SPRUCE STREET

CHIPSEAL AND DRAINAGE PROJECT
ORCAS ISLAND
COUNTY ROAD # 217 - PROJECT # 020904

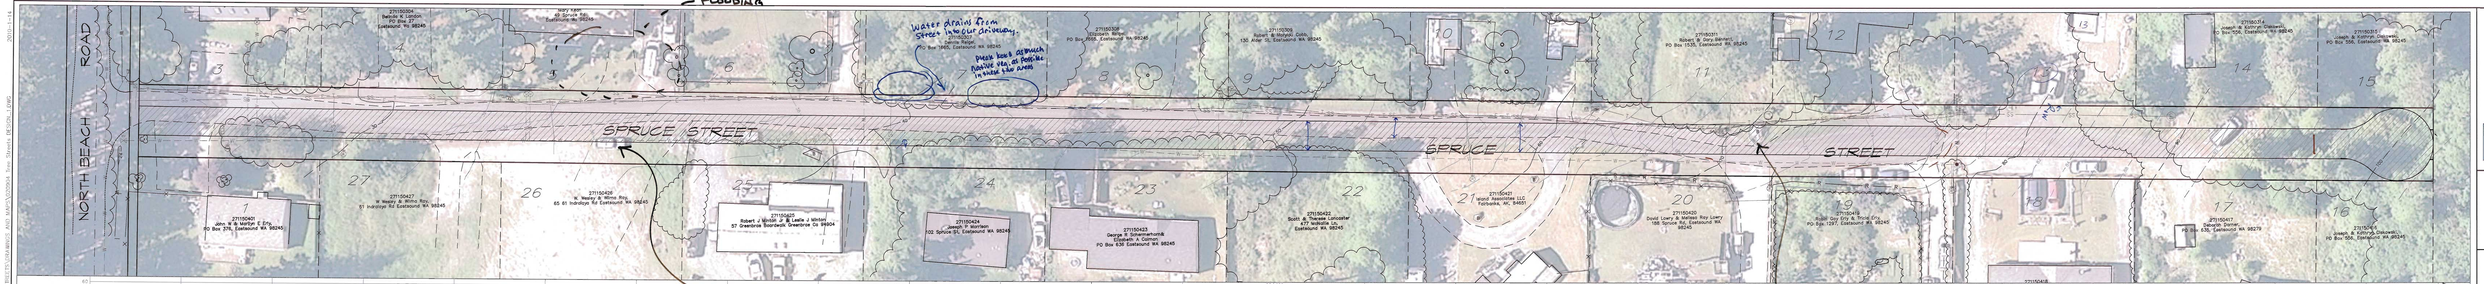
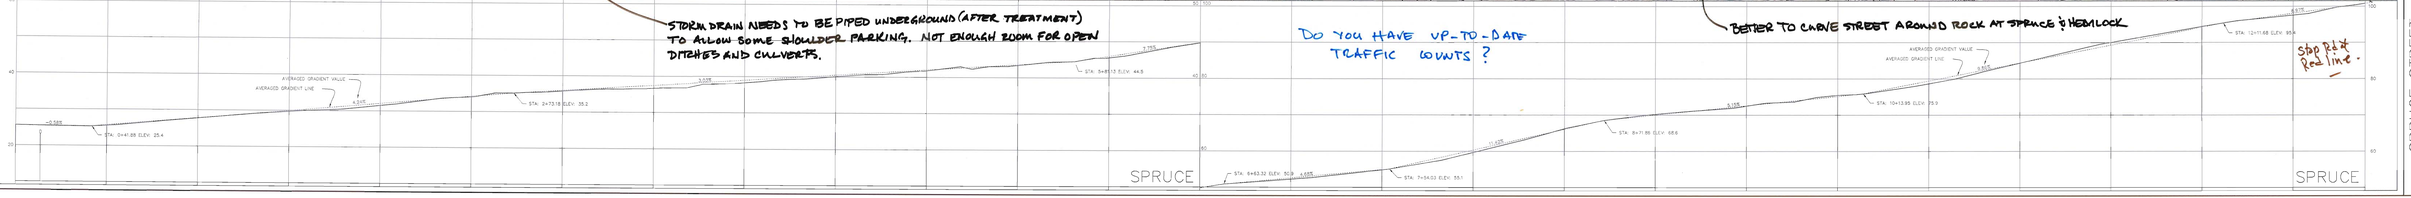
STORM DRAIN NEEDS TO BE PIPED UNDERGROUND (AFTER TREATMENT) TO ALLOW SOME SHOULDER PARKING. NOT ENOUGH ROOM FOR OPEN DITCHES AND CULVERTS.

DO YOU HAVE UP-TO-DATE TRAFFIC COUNTS ?

BETTER TO CURVE STREET AROUND ROCK AT SPRUCE & HEMLOCK
